SUPPLEMENTAL GEOTECHNICAL INVESTIGATION

PROPOSED TAILING DAM NO. 2

FEDERAL-AMERICAN PARTNERS

7.0 NRC QUESTIONS AND RESPONSES

FIG. D-5

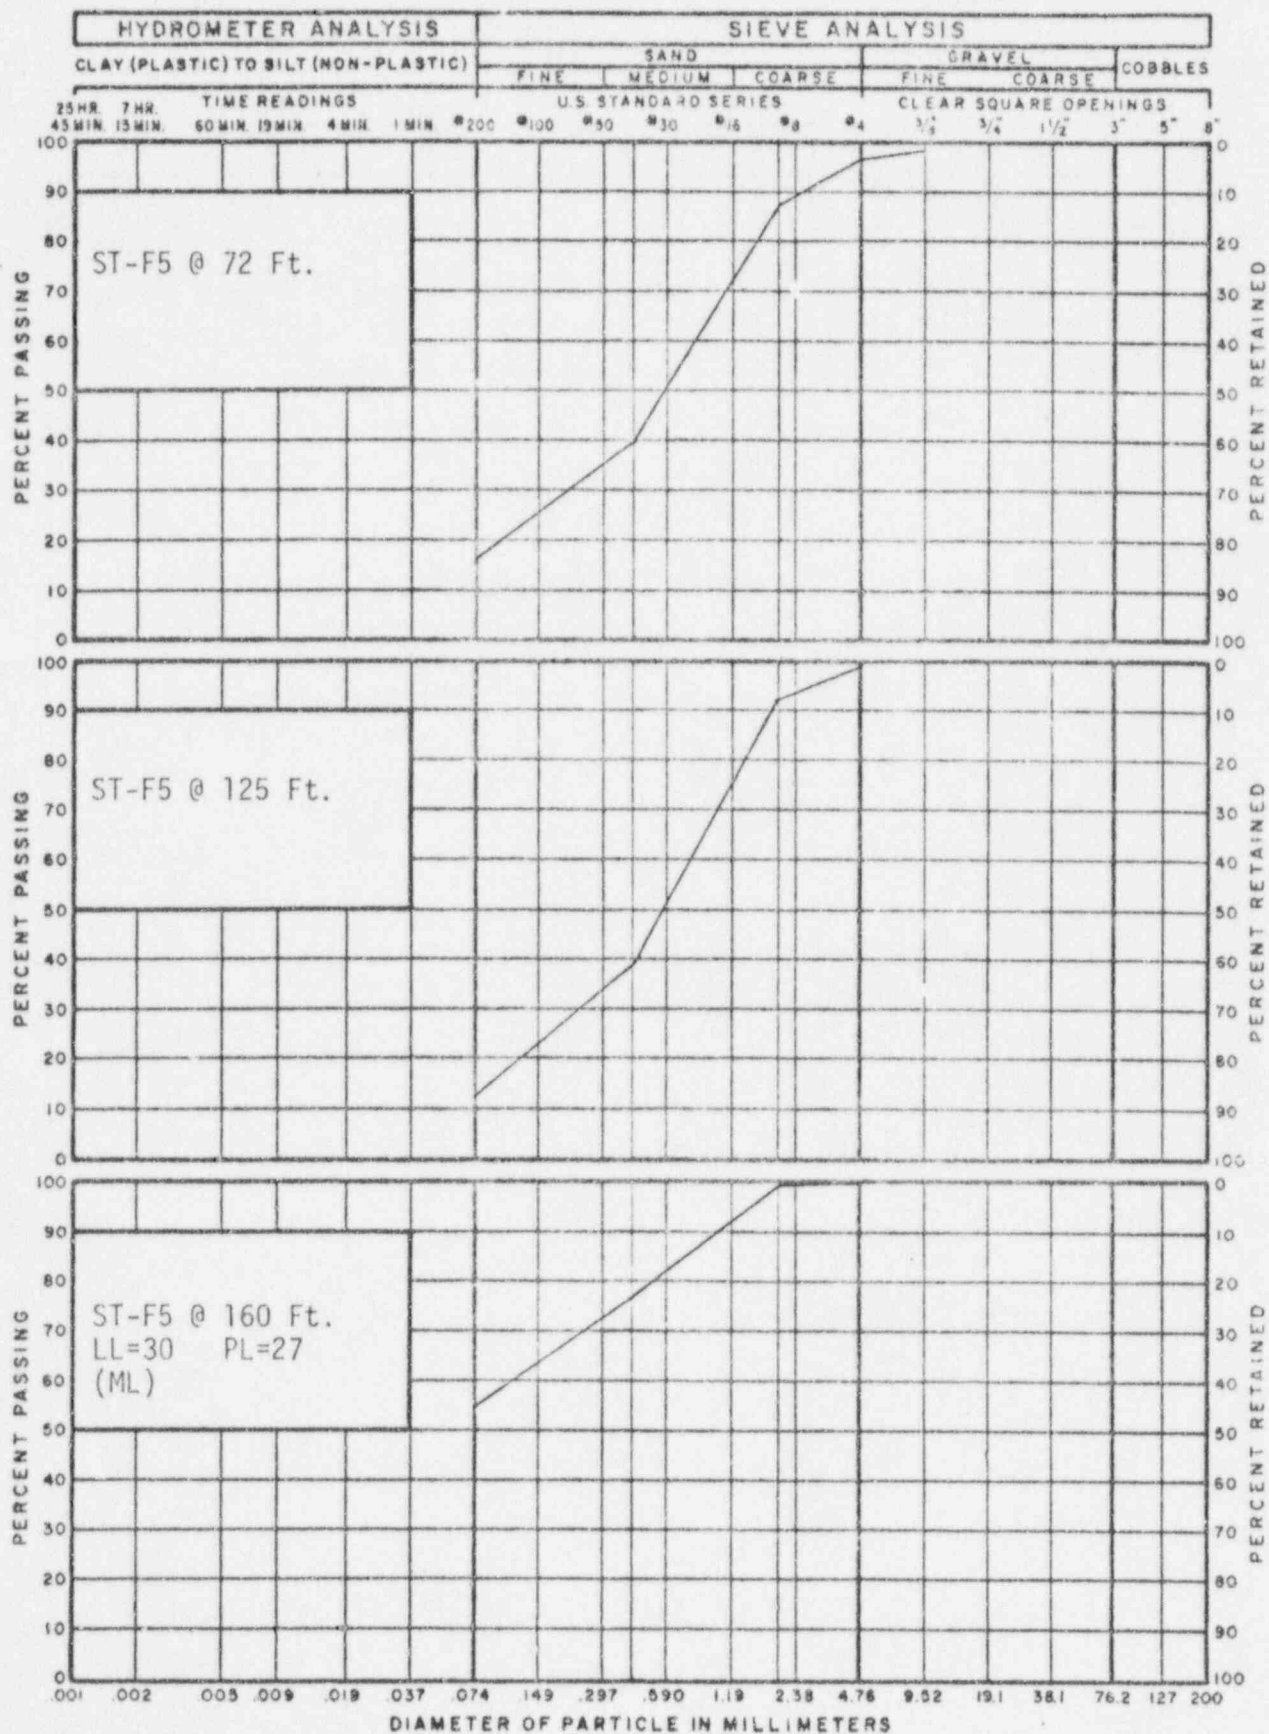
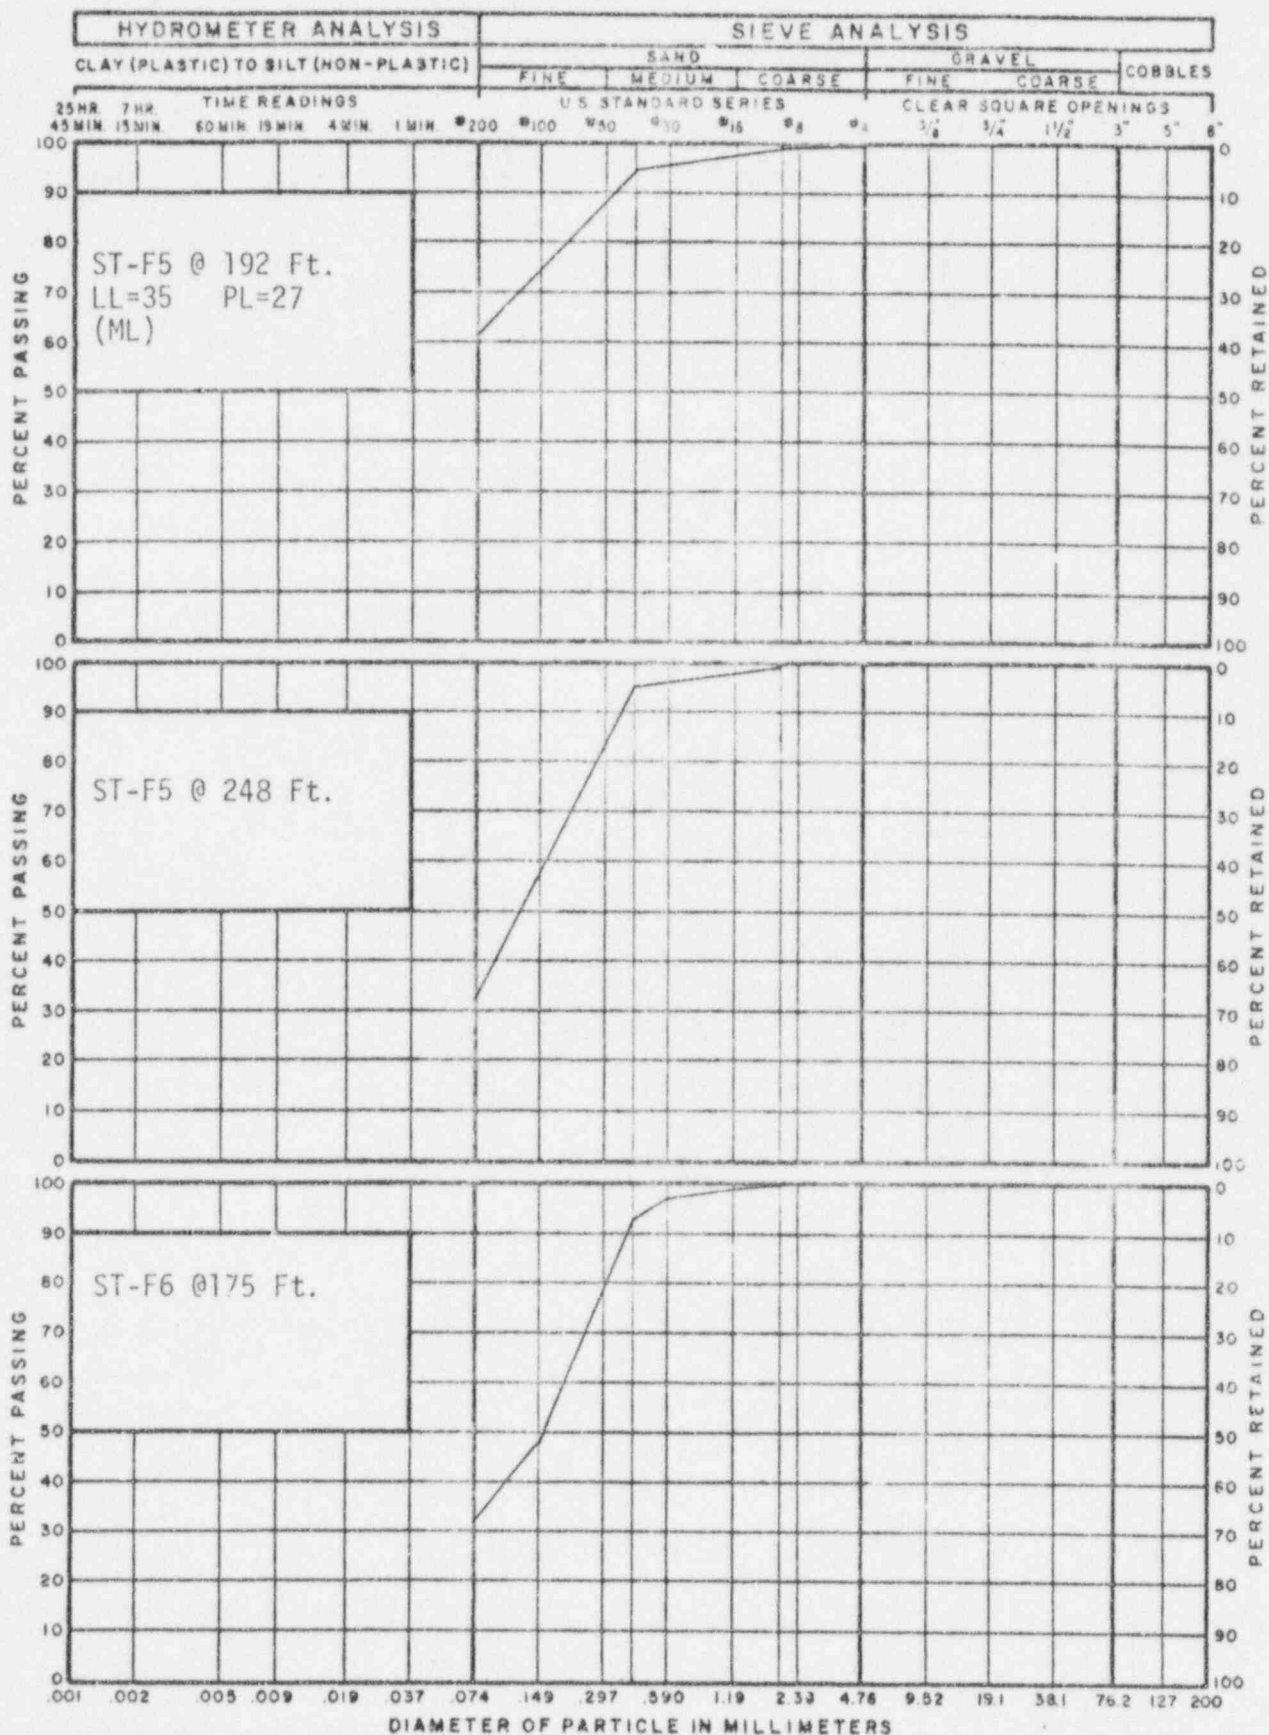
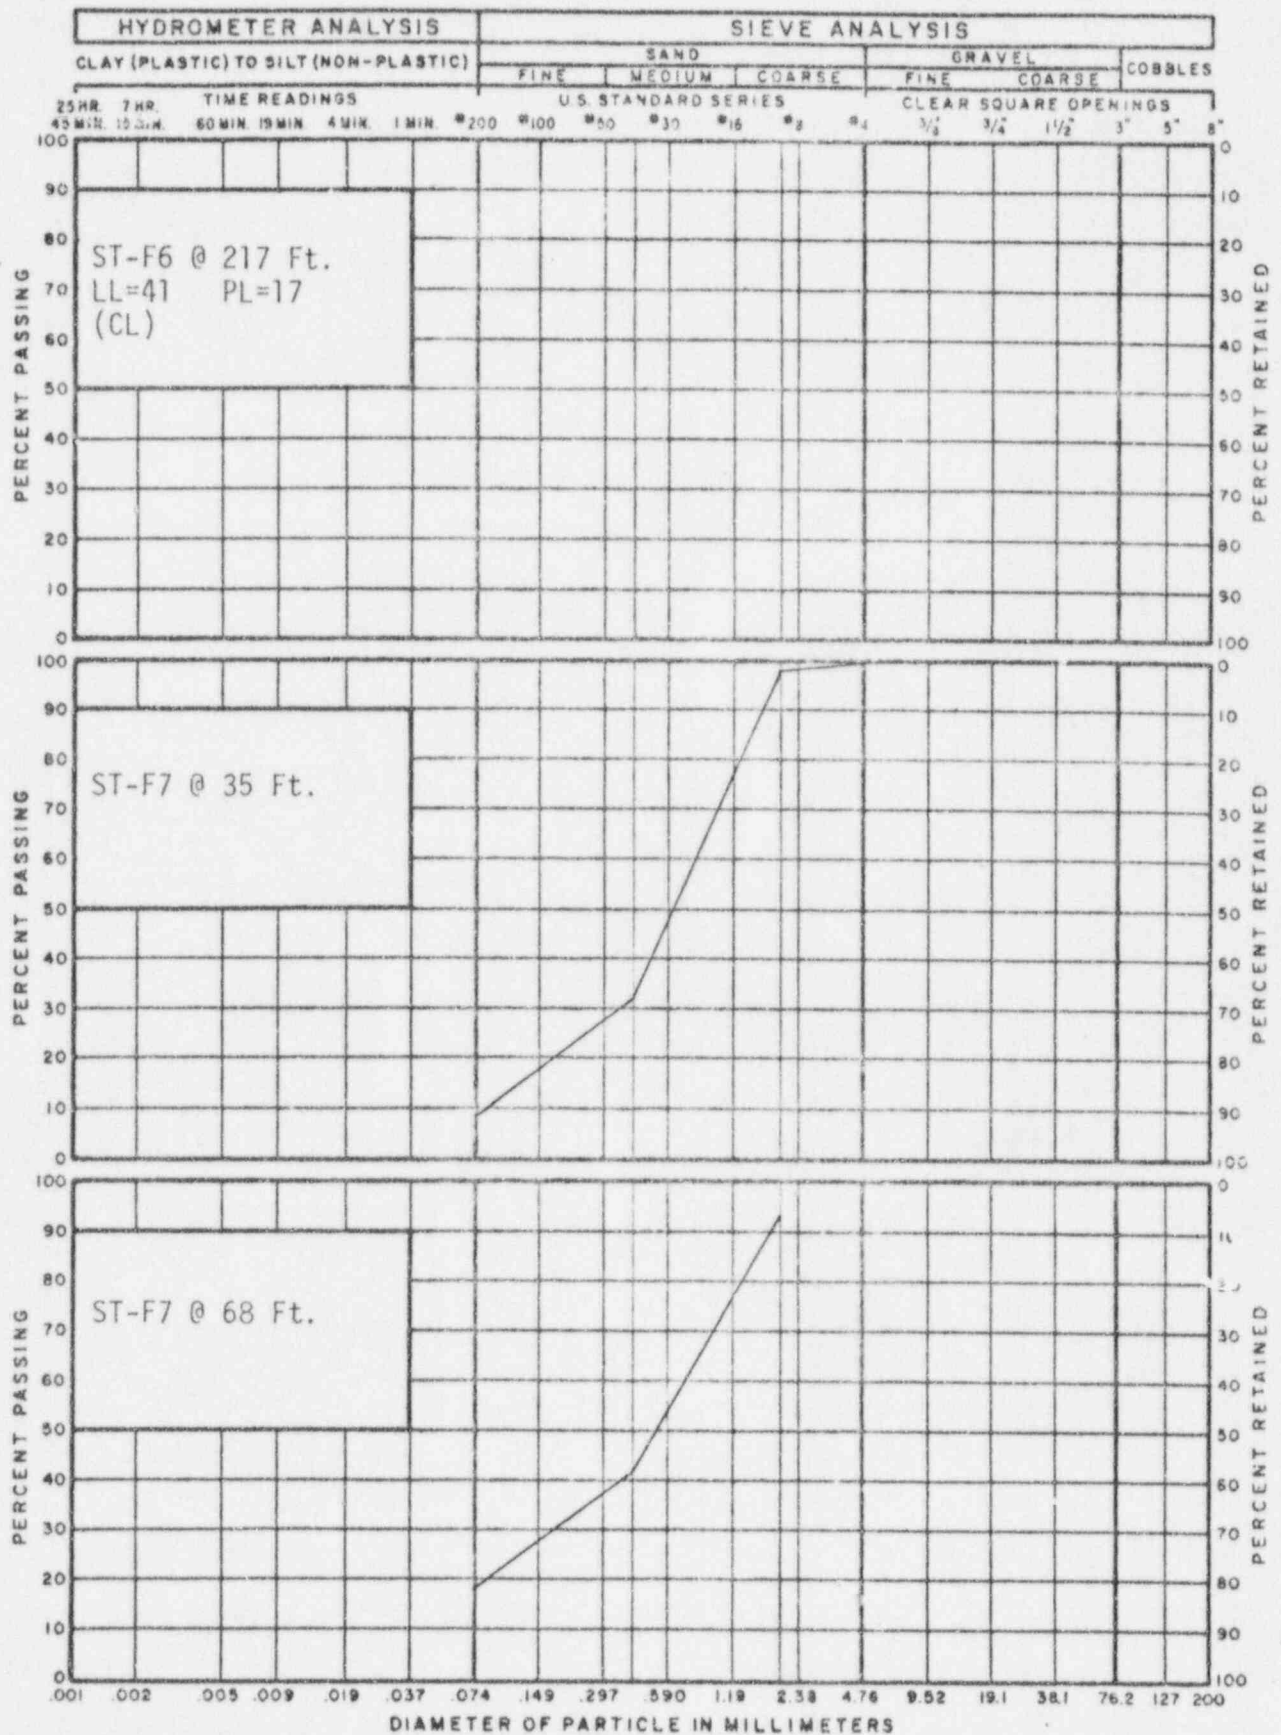
Provide details of the proposed borrow materials to be used for embankment construction. Include:

- a. A location plan showing areal extent of borrow area.
- b. Justification that adequate quantity of suitable material is available for embankment construction.
- c. The results of subsurface exploration of the borrow area. Include test boring and test pit logs.
- d. The results of laboratory tests on representative samples showing the soil properties and strength parameters for compacted fill materials as they will be used in embankment construction. Include identification tests, compaction and/or maximum-minimum density tests, permeability tests or estimates, strength tests.
- e. A comparison of the laboratory test results with the values assumed in design stability analyses. Provide revised stability analyses if the laboratory values are not compatible with the design criteria.

The original borrow material was to be removed from the western half of Impoundment No. 2, refer to Section 9.3 of our report Geotechnical Investigations for the Proposed Extensions of Tailing Dams No. 1 and 2, Job No. 1-1371-3454. The proposed borrow area is now designated as the Sagebrush-Tablestakes Pit. As we discussed in our meeting with the NRC, it would be sufficient to show that the now proposed borrow has similar mechanical

properties as that of the original borrow. In comparing the original borrow area material with that from the Sagebrush-Tablestakes extension area, both materials were found to be similar and suitable for use as embankment material. Refer to the enclosed sieve analysis, Figures B1-7 through B1-9 from our original report Geotechnical Investigation for the Proposed Extensions of Tailing Dams No. 1 and 2, Job No. 1-1371-3454, and Figures D-4 through D-7 along with our lithological logs A-3 through A-5 from our report Geotechnical Investigation and Design for the Subsurface Disposal of Millwaste, Job No. 1-1371-3771.

The estimated required volume of suitable borrow material for Tailing Dam No. 2 extension is approximately 1 million cubic yards. The available volume of suitable borrow material from the Sagebrush Tablestakes Pit exceeds this requirement, (i.e., the total volume of the pit is in excess of 12 million yards). Refer to Plate 1 of this report from our Geotechnical Investigation and Design of the Subsurface Disposal of Millwaste, Job No. 1-1371-3771, for existing and proposed Sagebrush Tablestakes pit limits.
